APPEAL SUMMARY

Appeal ID: 22219	Project Address: 1723 NW 24th Ave
Hearing Date: 12/11/19	Appellant Name: Nathan Cox
Case No.: B-019	Appellant Phone: 503-525-9315, x113
Appeal Type: Building	Plans Examiner/Inspector: John Cooley
Project Type: commercial	Stories: 1 Occupancy: M, B, F Construction Type: V-B
Building/Business Name: 24_Thurman	Fire Sprinklers: No
Appeal Involves: Alteration of an existing structure, Reconsideration of appeal	LUR or Permit Application No.: 19-126989-REV-01-CO
Plan Submitted Option: pdf [File 1]	Proposed use: Mercantile

PERMIT #19-126989-REV-01
Plumbing Fixture Code Appeal
November 4, 2019
(reconsideration 12/4/2019)

24_Thurman
Renovation+Improvements
Location:
1723 NW 24th Avenue
Portland OR 97210
Project No.:
160426
Issued for:
Code Appeal
Date:
November 4 2019
Revision:

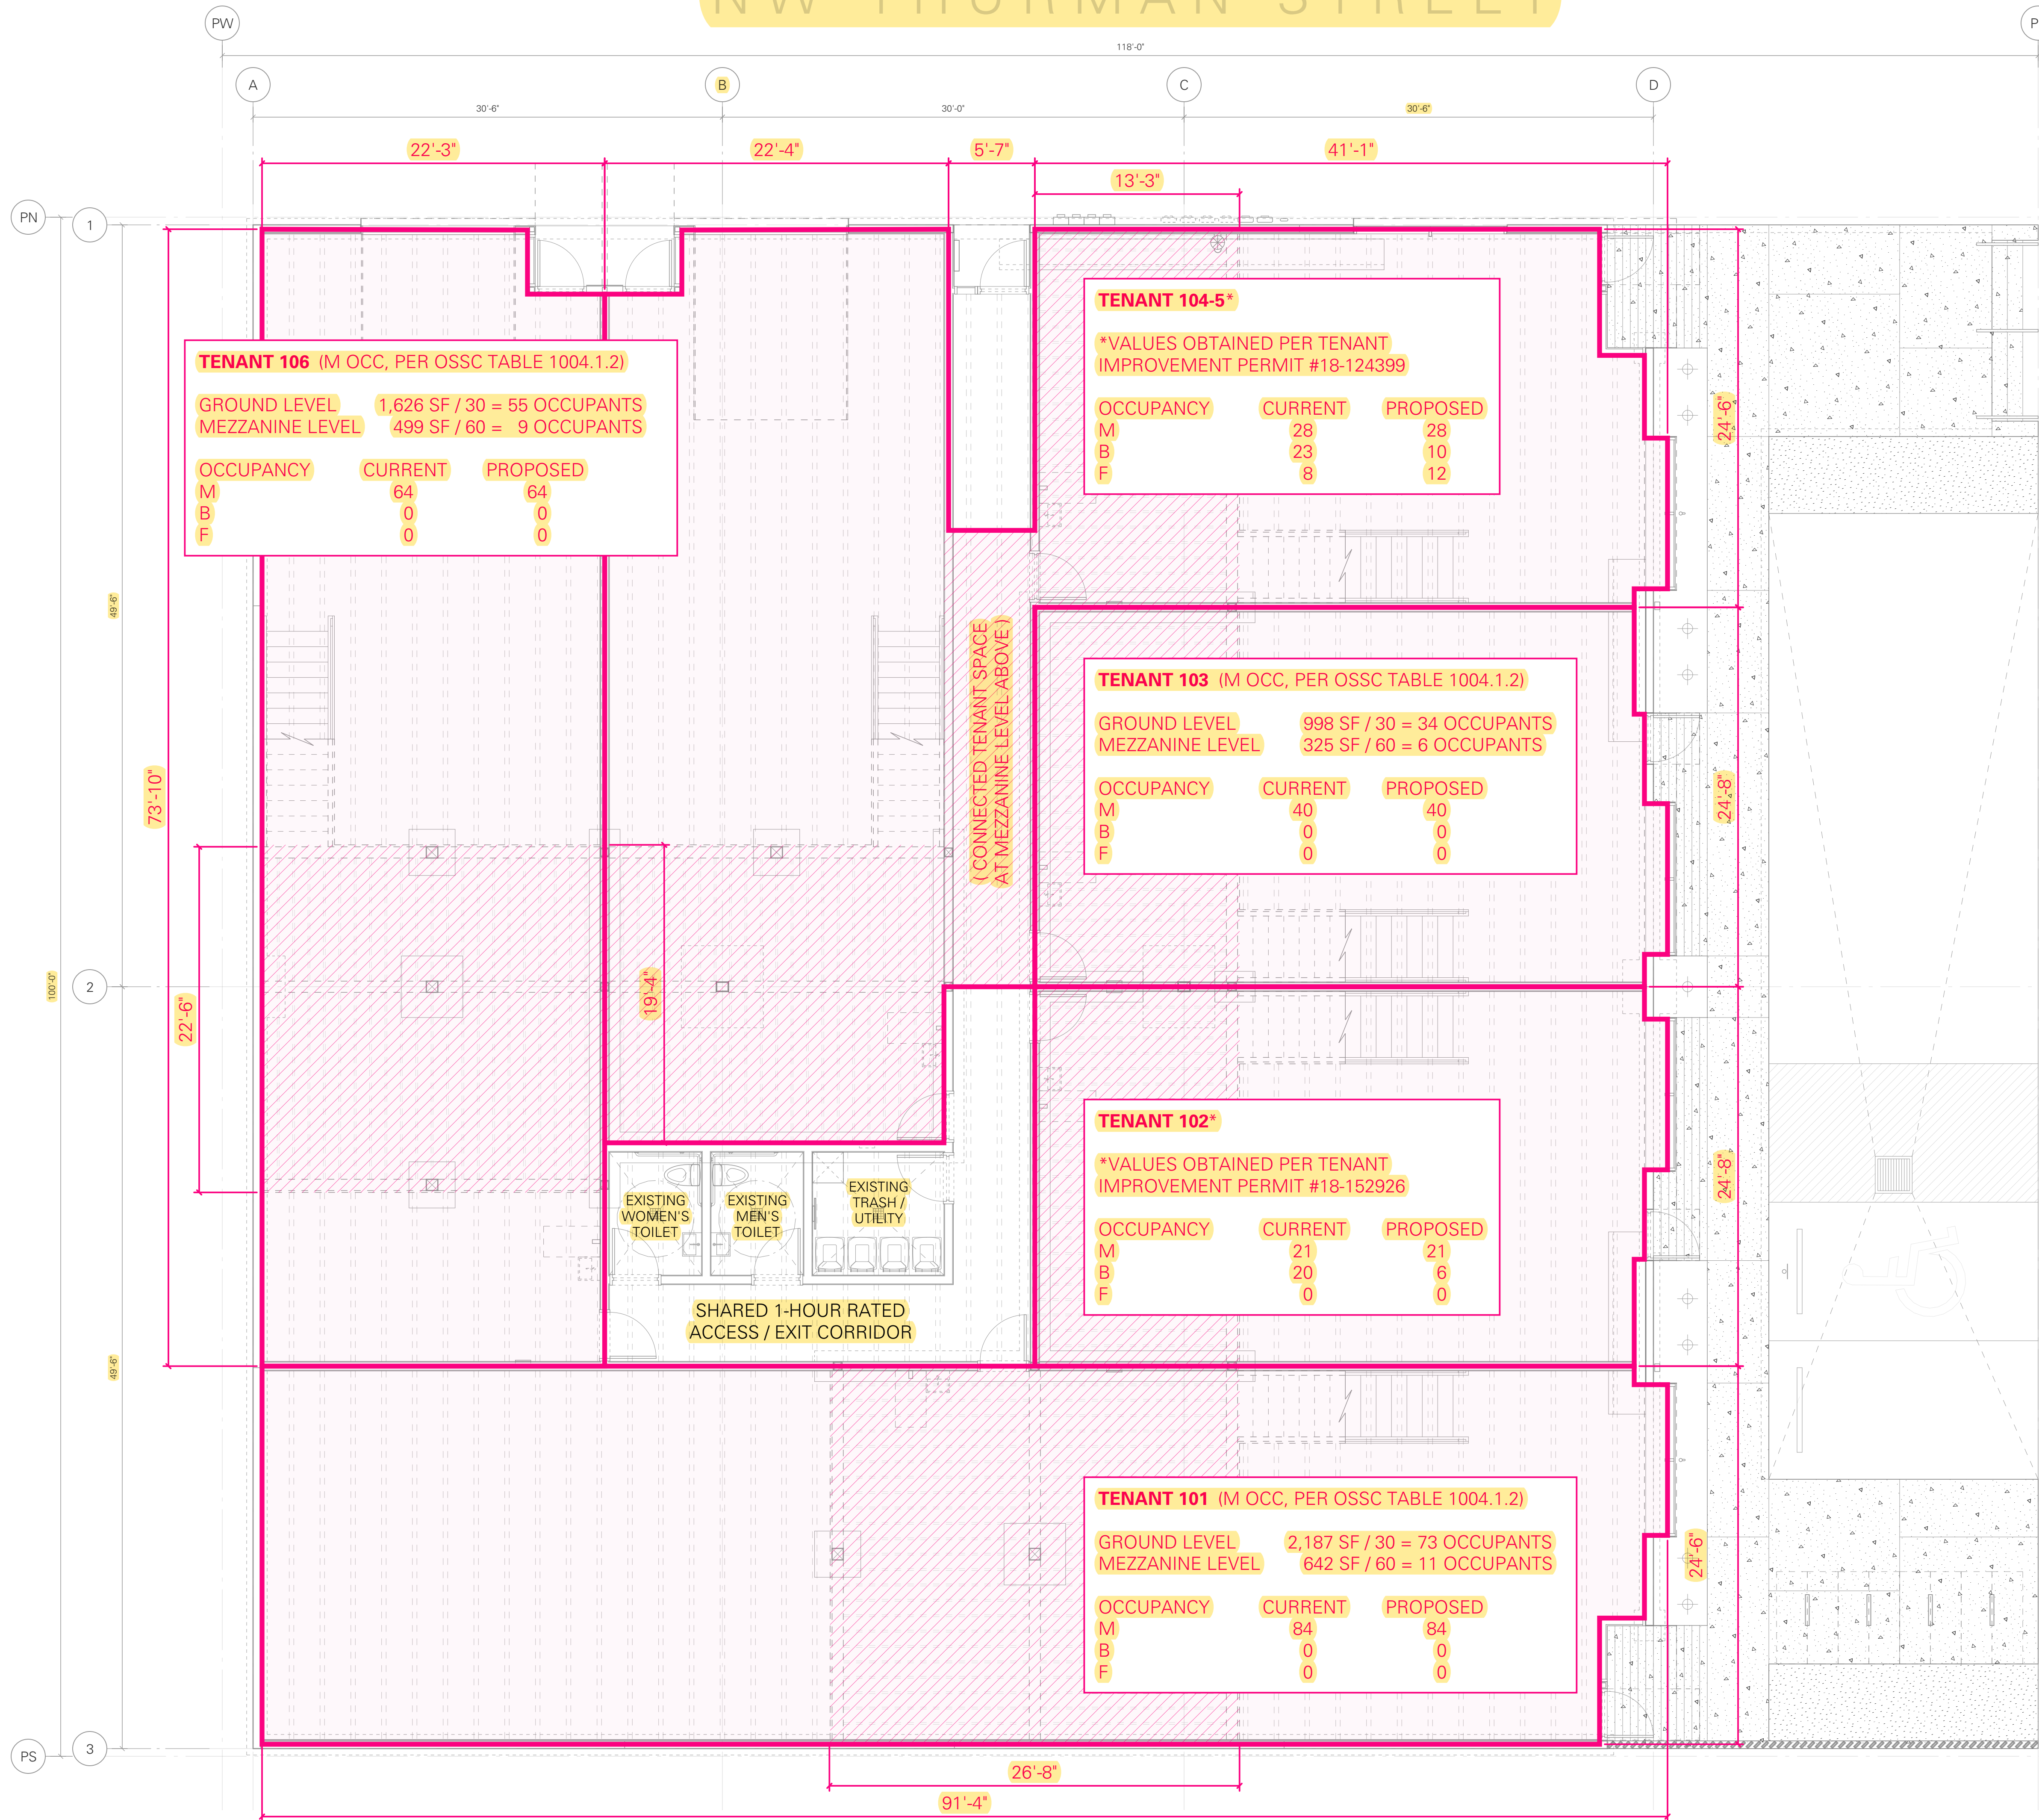
Permit #18-152926 (Tenant 102). This space is occupied by a small wellness clinic with 2 full-time practitioners and an occasional part-time lab assistant. Due to the size-limited nature of the business, there are never more than 3-4 employees and patients total in the space at a given time, so the application of 16 'B' occupants on the mezzanine level is excessive and unnecessary. It appears this was revised by hand at the permit counter by the applicant and/or reviewer. We are proposing to leave the 'M' portion of the space (at the front where health-related products are sold) as currently permitted.

Reduction in minimum required plumbing fixture count: Denied. Proposal does not provide equivalent sanitation facilities.

$1/4" = 1'-0"$ **PERMIT #18-152926 (TENANT 102)**

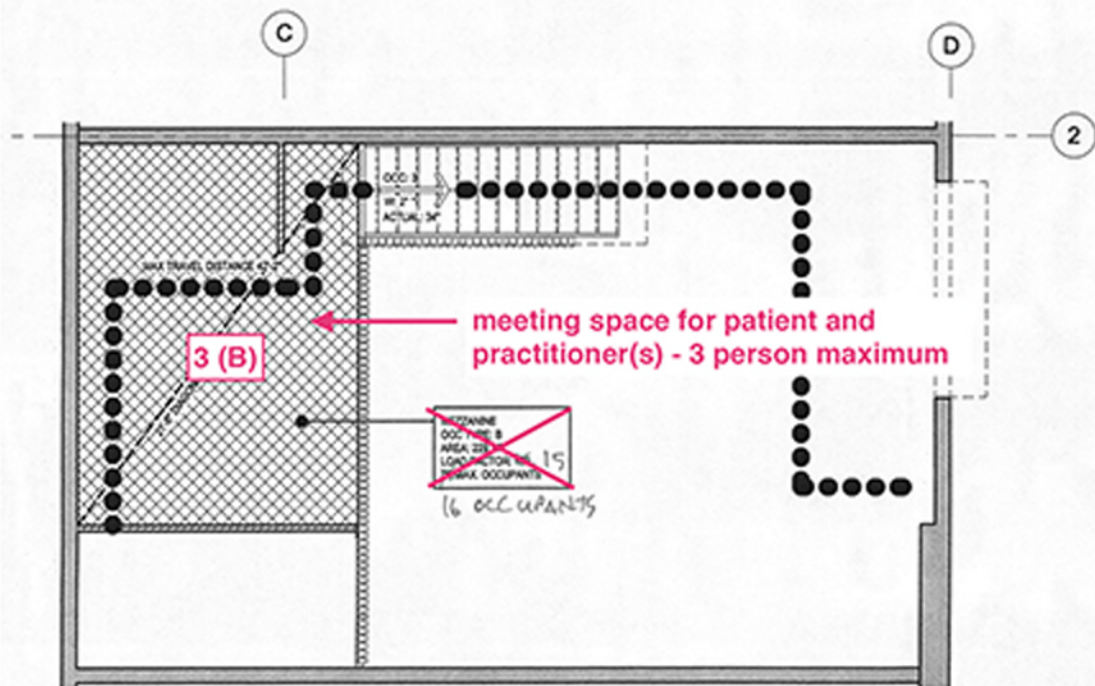
PROPOSED OCCUPANT LOADS BASED ON ACTUAL USES

$1/4" = 1'-0"$ **PERMIT #18-152926 (TENANT 102)**

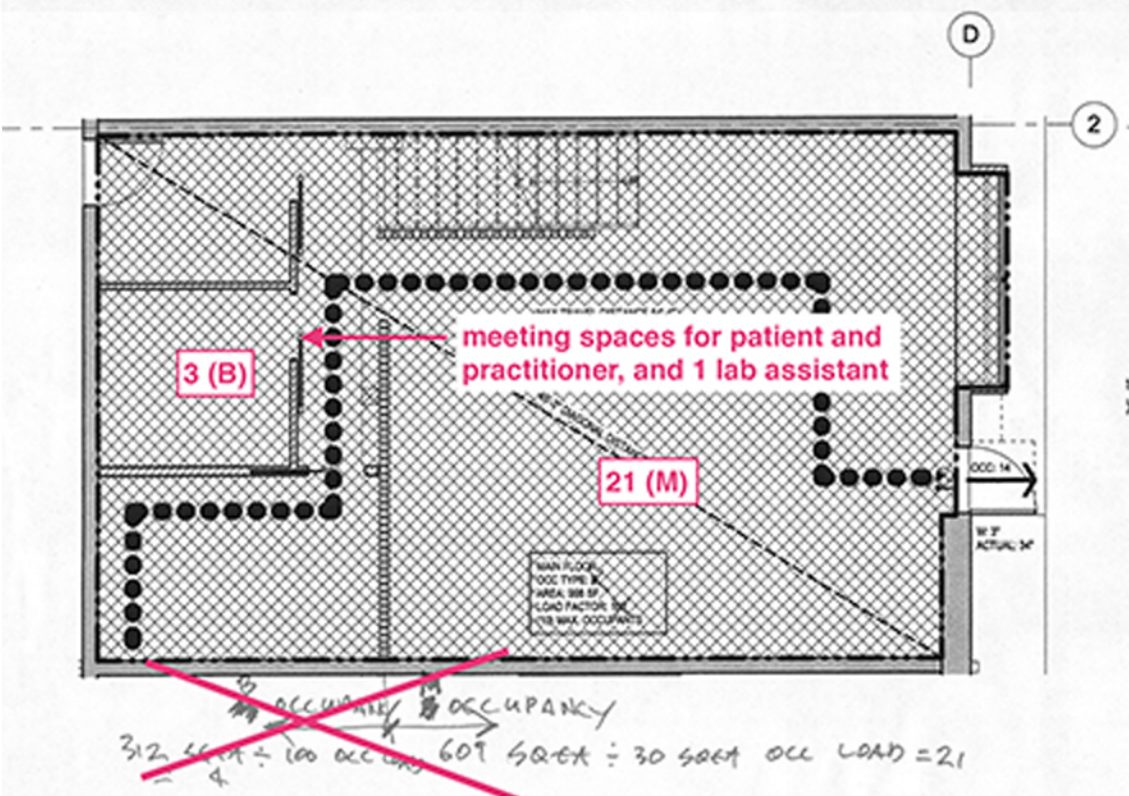
PROPOSED OCCUPANT LOADS BASED ON ACTUAL USES
